**SUBDIVISION,
PLANNED UNIT DEVELOPMENT
& ZONING AMENDMENT STAFF REPORT****Date: July 18, 2019****APPLICANT NAME**

Magnolia Manor Subdivision

LOCATION1624 Spring Hill Avenue
(North side of Spring Hill Avenue, 100'± East of USA
Childrens and Womens Parkway).**CITY COUNCIL
DISTRICT**

CONTEMPLATED USESubdivision approval to create 1 legal lot of record,
Planned Unit Development approval to allow multiple
buildings on a single building site, and Rezoning from R-1,
Single Family Residential District, to B-2, Neighborhood
Business District.**It should be noted, however, that any use permitted in
the proposed district would be allowed at this location if
the zoning is changed. Furthermore, the Planning
Commission may consider zoning classifications other
than that sought by the applicant for this property.****TIME SCHEDULE
FOR DEVELOPMENT**

SITE PLAN

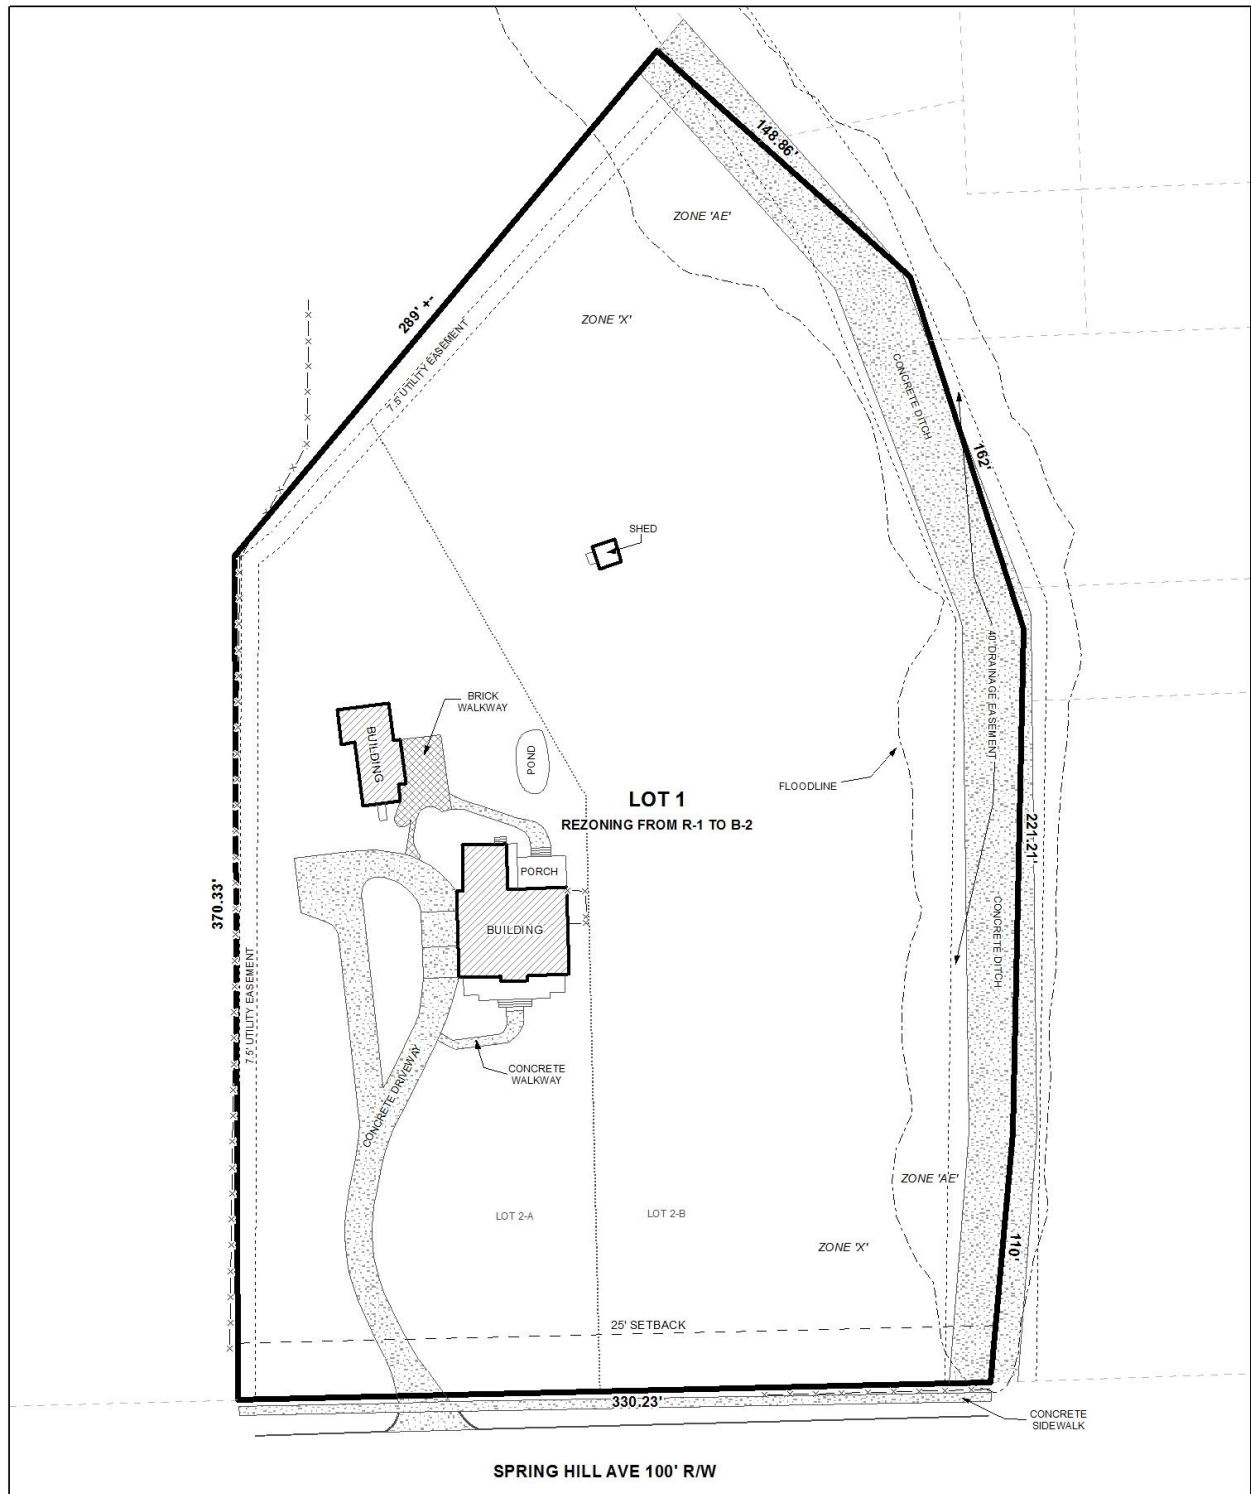
The site is developed with an existing two-story, 3,412 square foot residence, and an 877 square foot detached carriage house. The site plan references a 1,400 square feet for the reception space and a total of 50 parking spaces. The parking ratio for a reception space is one space per four seats. Neither the site plan nor the narrative illustrate how many seats the venue can hold; what the remaining 2,012 square feet of the main structure would be used for; or how the carriage house would be utilized.

During a previous pre-development meeting it was stated that the upstairs portion of the main structure could possibly be utilized as a bed and breakfast, or a place for the bride and or family to stay overnight prior to utilizing the venue. The site plan should be revised to reflect the square footage of the first floor as well as the square footage of the second floor, and to depict the total number of seats that can be placed within the reception area based on the total square footage of the area. The narrative should also be revised to explain in detail the use of the second floor of the main structure, as well as the use of the carriage house, and if there are to be any additional features such as a permanent bar, etc. to be placed outside the main structure.

There is no dumpster illustrated on the site plan. If approved, the site plan should be revised to illustrate any proposed dumpsters, with any new dumpsters to be in compliance with Section 64-4.D.9. of the Zoning Ordinance. If no dumpster will be used on the site, such should be noted on the PUD site plan.

Due to the site plan specific nature of PUD approval, it should be noted there appears to be 2 handicap accessible parking spaces on the site, but there does not appear to be any ramps indicated on the plan. The site plan should be revised to depict any modifications or improvements required due to accessibility requirements to include Building Code or ADA.

DETAIL SITE PLAN

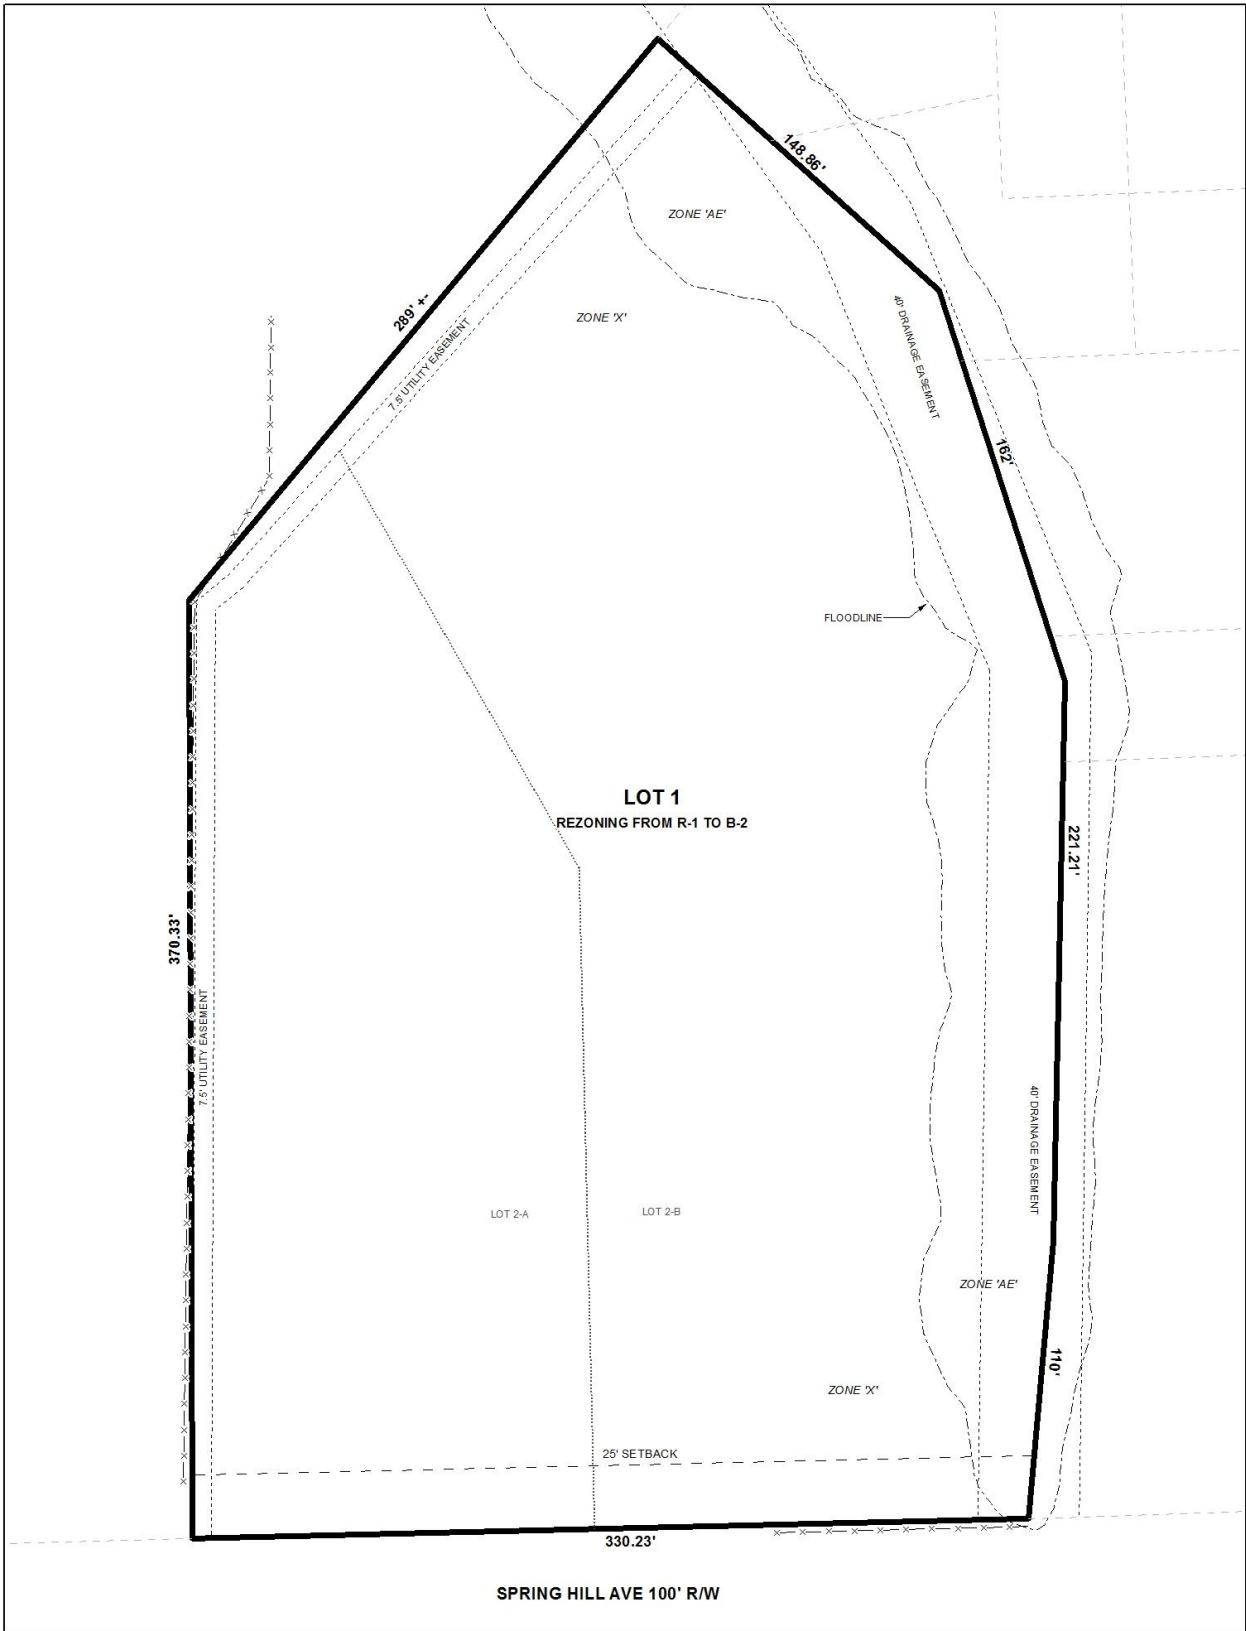
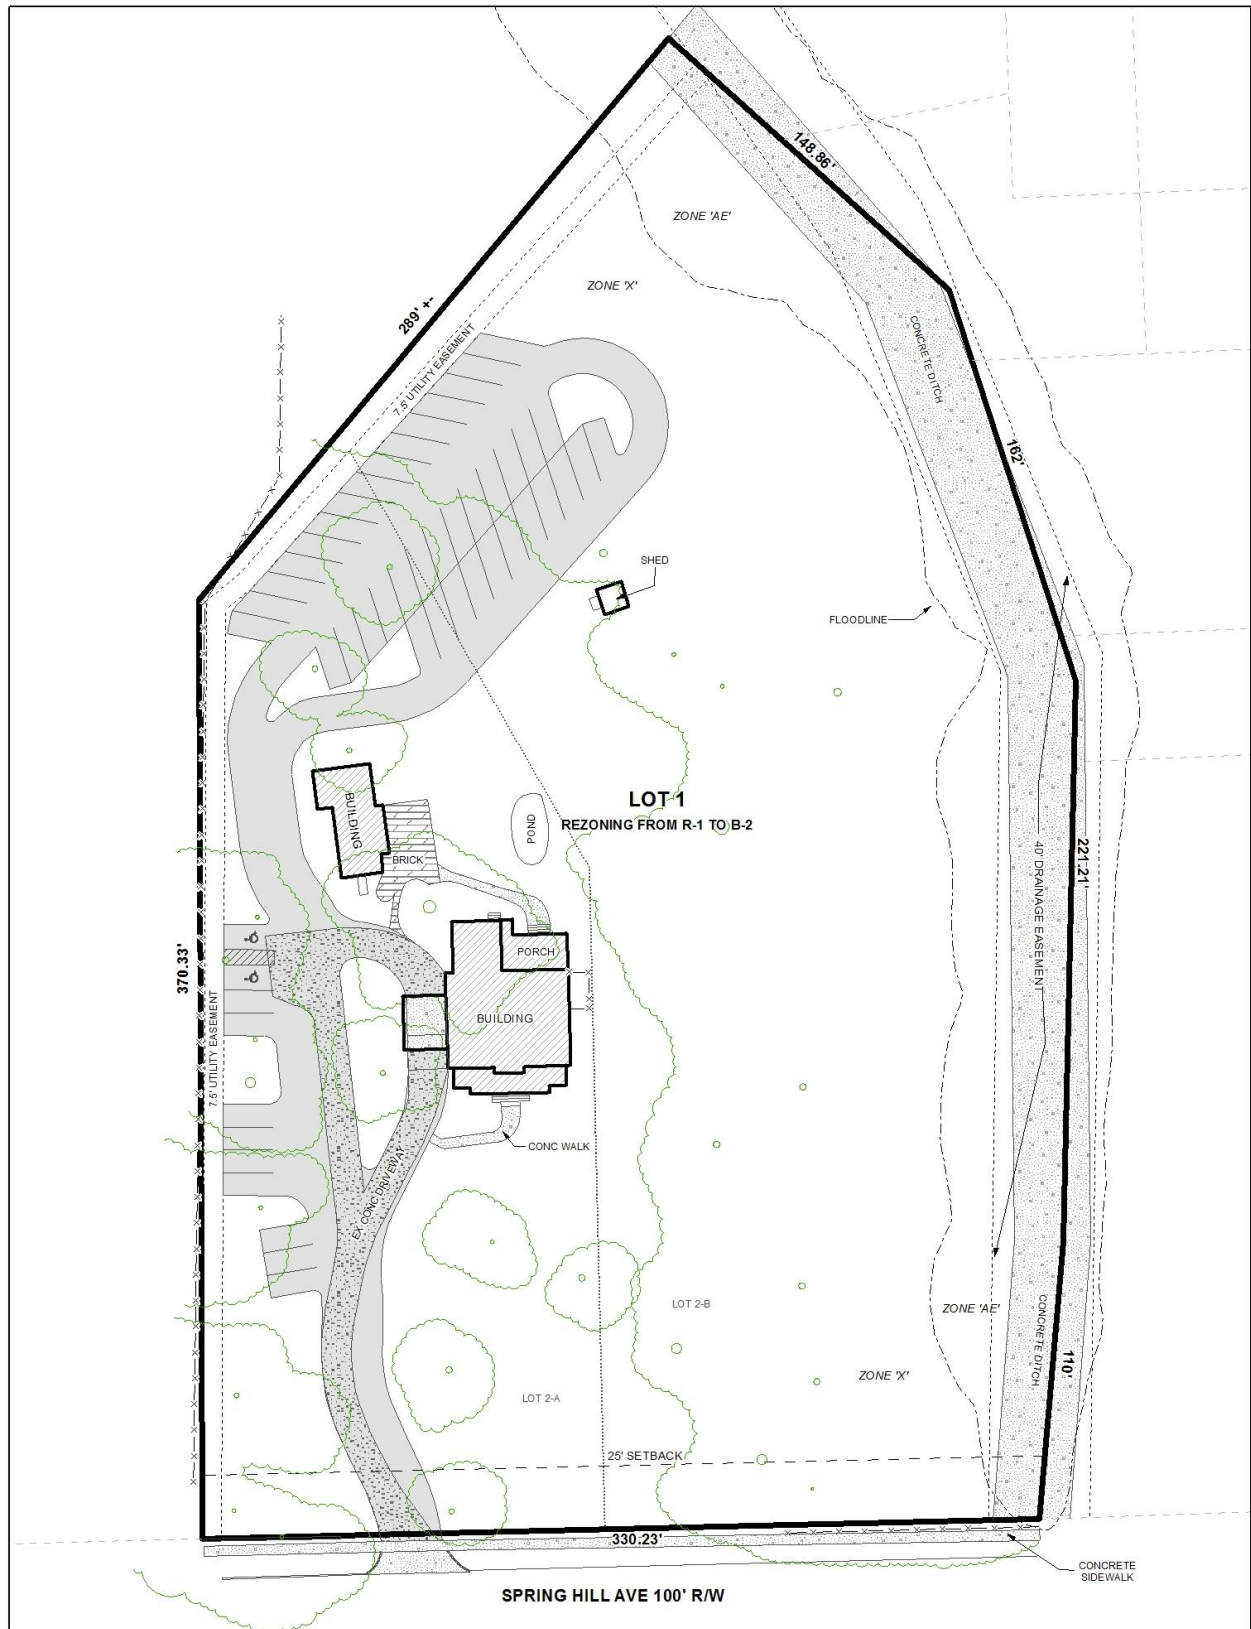
- bearings and distances) that is required by the current Alabama State Board of Licensure for Professional Engineers and Land Surveyors.
- B. Clarify which of the three (3) SUBDIVISION PLAT drawings is the PLAT. All three (3) are labeled SUBDIVISION PLAT and labeled as SHEET 1 OF 1.

- C. Provide and label the monument set or found at each subdivision corner. Many corners are labeled NIF.
 - D. Clarify the meaning of "FLOODLINE".
 - E. Clarify how there is a RECORD (R) bearing and an ACTUAL (A) bearing provided along the east property line if no existing irons were found or set?

- G. Show and label all flood zones including the X(shaded) flood zone.
 - H. Show and label the MFFE (Minimum Finished Floor Elevation) on each lot that contains an AE, V, or X (shaded) flood zone designation.
